**Before the Panel Convener appointed under the
Fast-track Approvals Act 2024**

In the matter of Mt Welcome, Pukerua Bay

By Pukerua Property Group Limited Partnership

Response to Panel Minute 4

Figure 1: Schematic provided by Panel in Minute 4

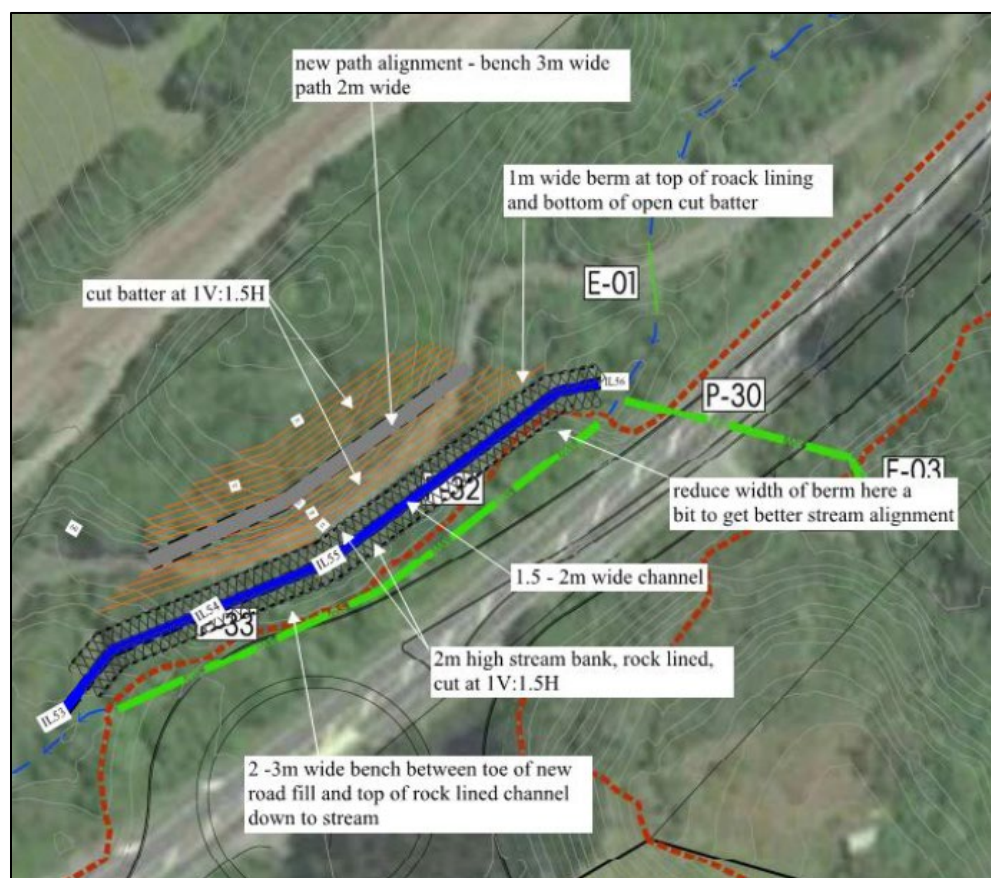
- 14 The Panel has proposed an alternative option to construct a realigned section of stream to the west of the proposed roundabout to eliminate the need for a culvert, along with a schematic image shown in Figure 1 below.

- 15 Envelope Engineering have reviewed the alternative option and provided a concept plan which is attached as **Appendix B**. They note that this design would require:

- 15.1 Approximately 12,500m³ of cut (no fill) and 3,600m² of additional earthworks area;
- 15.2 3,050m² of additional vegetation clearance from SNA027;
- 15.3 To recreate the existing path alongside the northern side of the stream, a 5m bench platform is required that provides for a path with a berm on both sides (also allows for maintenance vehicle access);
- 15.4 1:2 average batter slopes allowing for 1:1.5 in rock and 1:2.5 slopes in Loess; and
- 15.5 New Stream length would be ~125m, with the existing alignment being ~130m.

- 16 The Panel seeks: “an analysis of the pros and cons of the concept shown above, or variations thereof that the applicant’s advisors might identify, relative to the culverting proposed”. These are set out in **Appendix C** below by topic which is informed by:
 - 16.1 Dr Vaughan Keesing (BlueGreen Ecology) with regard to ecological matters;
 - 16.2 Brad Dobson (Blac) with regard to landscape matters; and
 - 16.3 Torrey McDonnell (Incite) with regard to planning matters.
- 17 In summary, Appendix B outlines that:
 - 17.1 The project ecologist considers that the loss of 3,050m² of SNA associated with the alternative concept proposed by the

Panel is a less desirable outcome in his opinion to the proposed culvert design.

17.2 The project landscape architect considers that on balance, the proposed culvert design represents the more favourable outcome from an overall landscape and visual effects perspective than the alternative concept proposed by the Panel. It avoids the greater visual effects on the escarpment landform and SNA vegetation while affecting a relatively low visibility section of stream with limited public interaction. The proposed culvert option is therefore preferred in his opinion as more of a known quantity/outcome than the alternative.

17.3 The project planner considers that at a high level, while both options require consent under the same sets of district and regional rules, they have different effects profiles that would need to be managed. Further, there may be challenges with the stream realignment option in terms of Clause 3.11 of the National Policy Statement for Indigenous Biodiversity.

- 24 For the reasons set out above, the applicant considers that the proposed culverting option remains the most appropriate option currently available. The alternative concept may avoid a section of culvert, but it introduces materially greater earthworks, additional SNA vegetation clearance, greater uncertainty around rehabilitation and offsetting, and unresolved feasibility and stakeholder issues. The applicant therefore

does not support progressing the alternative concept on the information presently available.
